Airport Moving Map Alert

Subject: Varna, Bulgaria
Varna (LBWN)
Cycle 2204 and 2205

Stands layout incorrect. TWYs names incorrect.

20 MAY 22 **JEPPESEN** (10-9A)

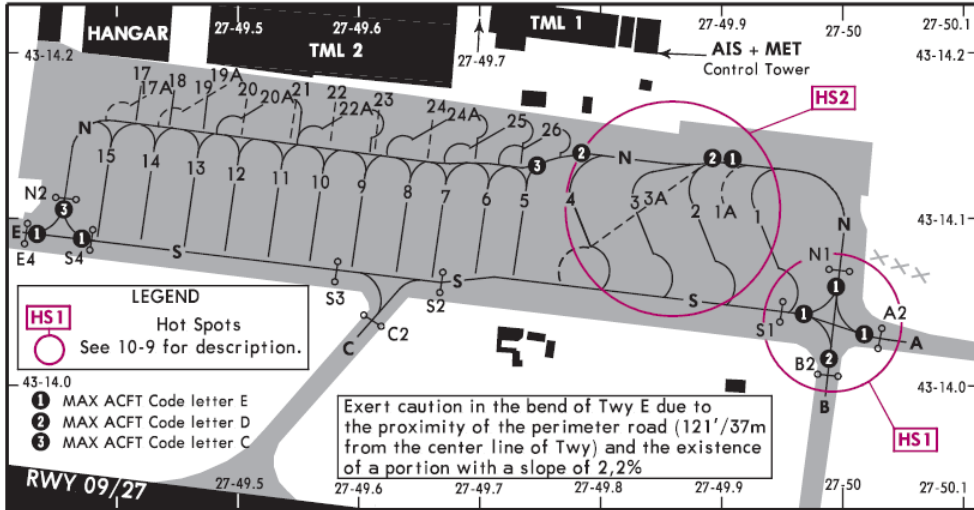
Jeppesen Airport Moving Map and A816 formatted data for cycle 2204, effective 21 April 2022, and for cycle 2205, effective 19 May 2022, contain incorrect data for Varna; Varna, Bulgaria (LBWN). Bulgaria AIP SUP 03/22, published 06 May 2022, effective 16 May 2022, introduced “Construction works at Varna aerodrome” for the extension of the apron, which are now completed. Following changes (effective 16 May 2022) are not reflected in the data, as SUP was received after 2204 AIRAC cycle data processing due date:

- Parking Stands 5A, 14A, 16 are withdrawn
- Parking Stands 17A, 19A, 25, 26 are added
- Parking Stand 15 is relocated
- TWY A (between TWY E and TWY B) is renamed to TWY N
- TWY E (between new Stand 15 and TWY B) is renamed to TWY S

Revised data will appear in Jeppesen Airport Moving Map and A816 formatted data for cycle 2206, effective 16 June 2022. Until then this Alert will be posted on the Jeppesen Web site: [Notices and Alerts](#). Please refer to the local NOTAMs and Varna, Bulgaria (LBWN) 10-9A chart dated 20 May 2022 for valid information.
